Re: Response to Review Comments – Ruby Meadows Subdivision

RUBY MEADOWS SUBDIVISION
ALBION ROAD & POPE ROAD
WINDHAM, MAINE

ROADWAY PLAN & PROFILE

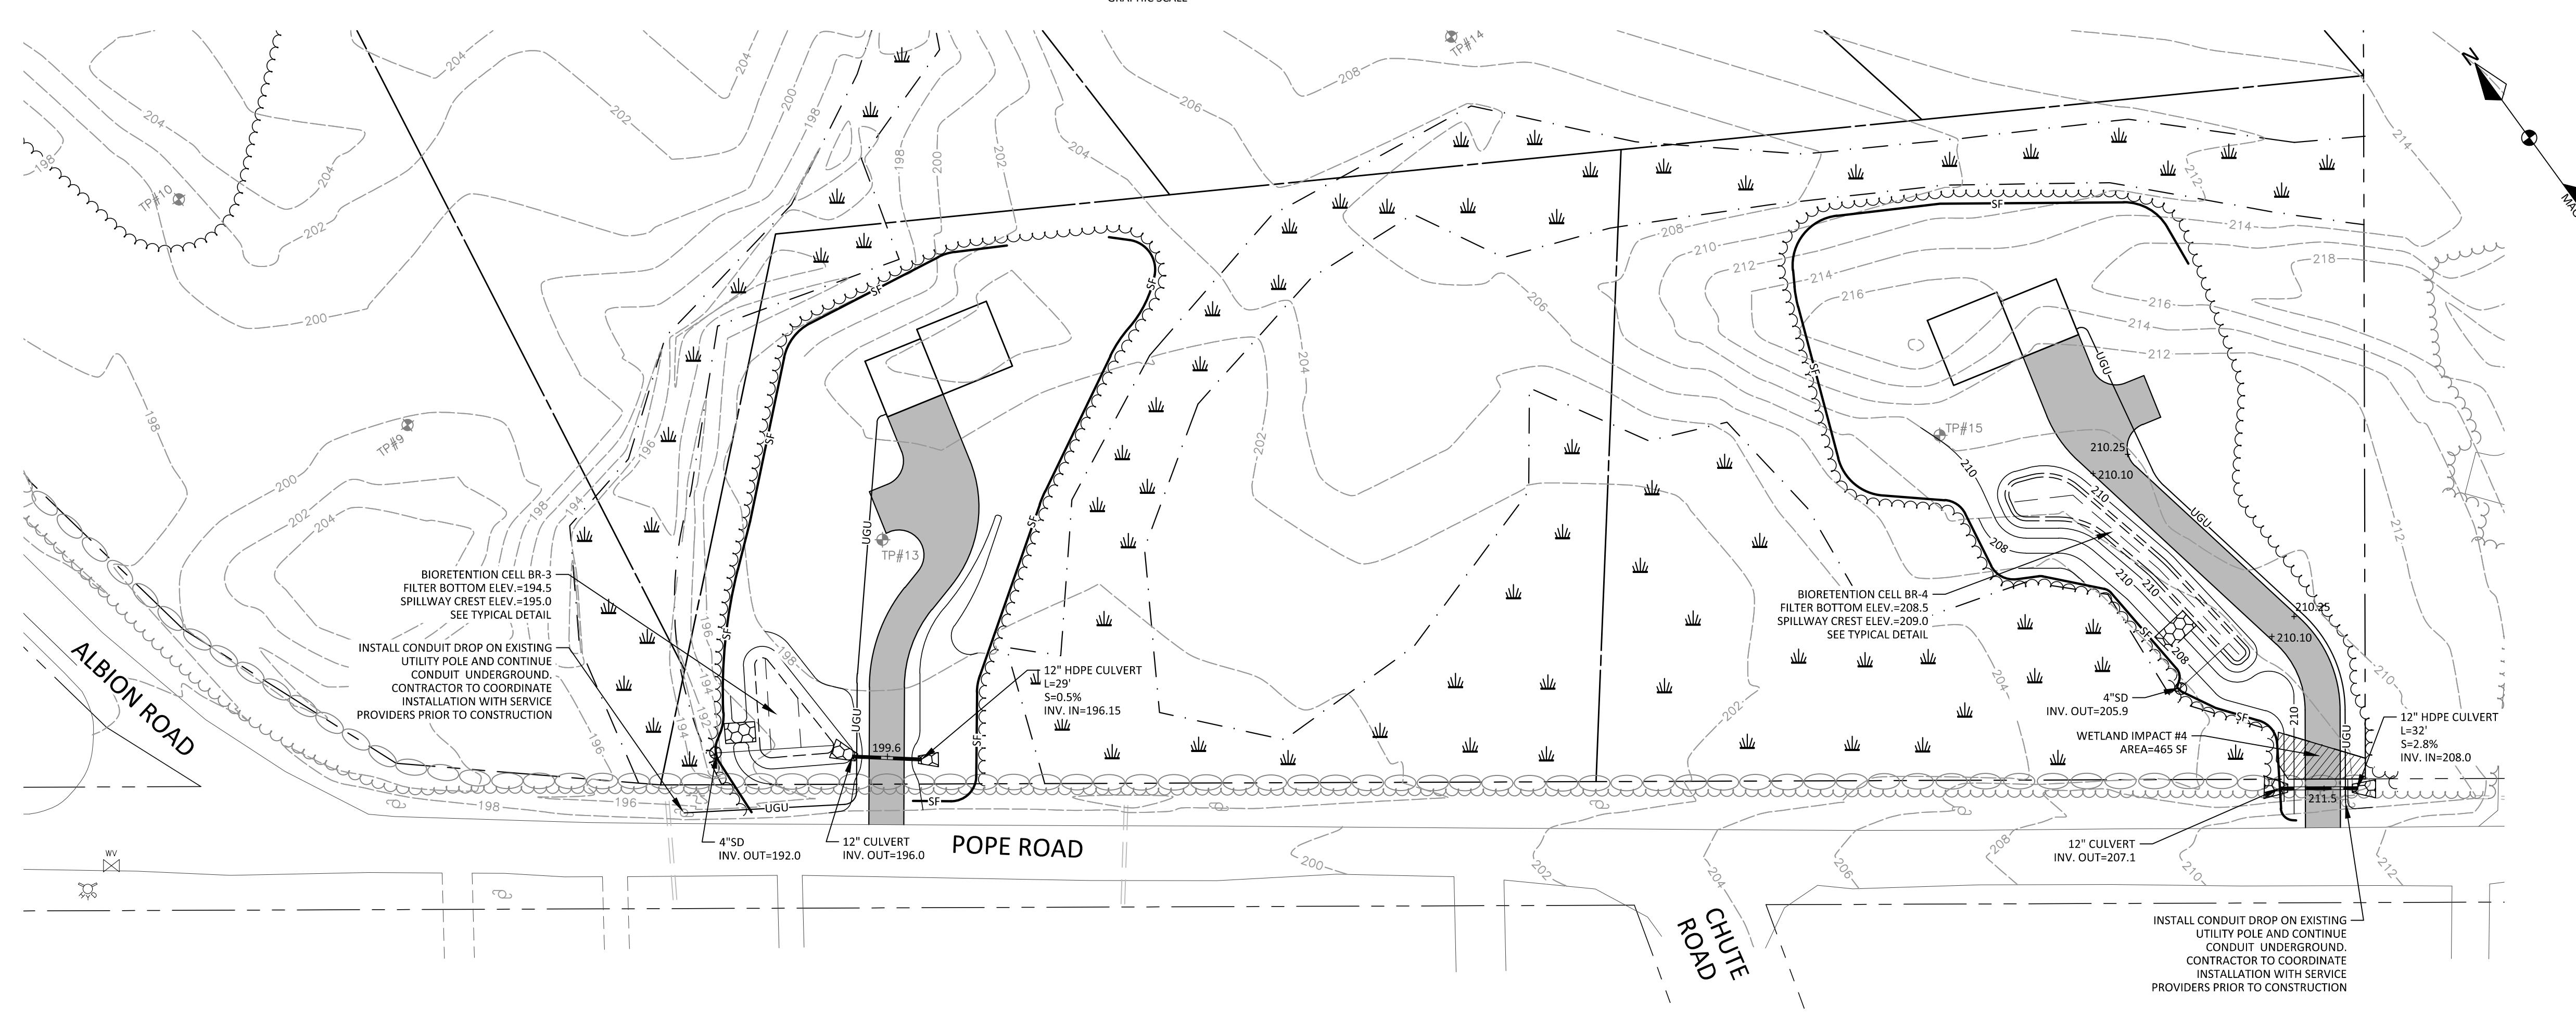
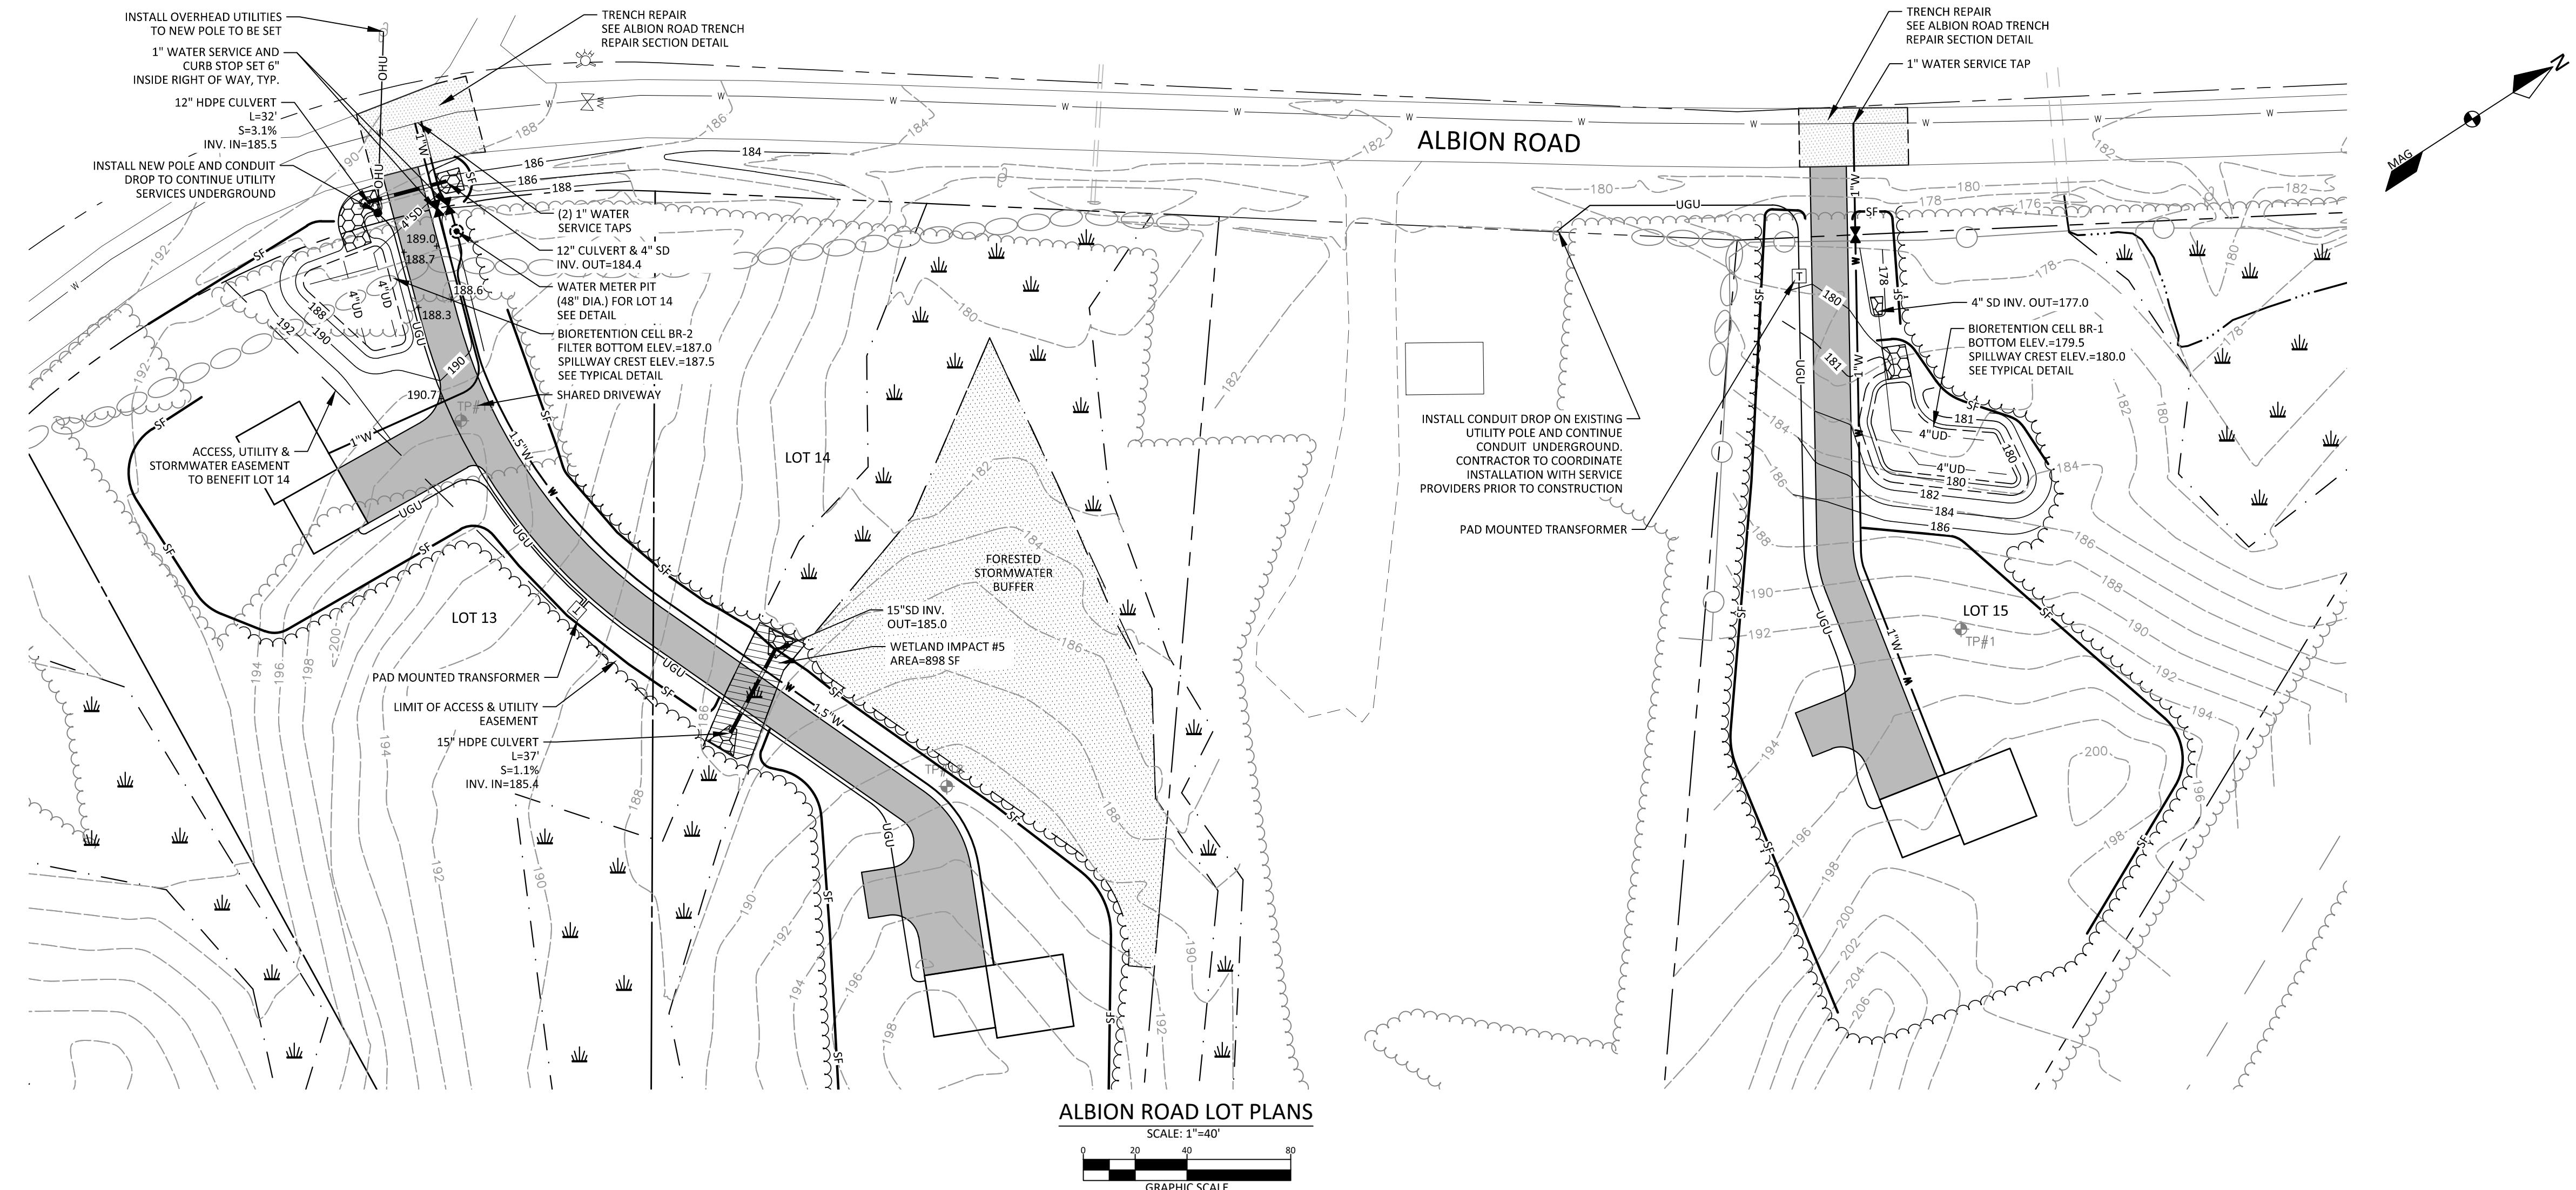
18. A revised Plan and Profile drawing is attached, which labels the sight distance at the proposed roadway intersection.
19. A roadway restoration detail was added to the plans showing the required trench repair and surface restoration for roadway trenching in Albion Road, which is under moratorium.
20. A revised Stormwater Management Report is attached, which correctly labels the pre-development flow rate at Study Point 1 as 7.18 CFS.
21. We propose that ground topography of the stormwater filter basins and rain gardens be surveyed as a condition of preliminary approval and prior to final approval.
22. A revised Lot Development Plan is attached, which shows proposed grading for the bioretention cells on lots 1, 2, 13, 14 and 15.
23. A summary table showing the proposed impervious and developed area on each lot was added to the Subdivision Plan.
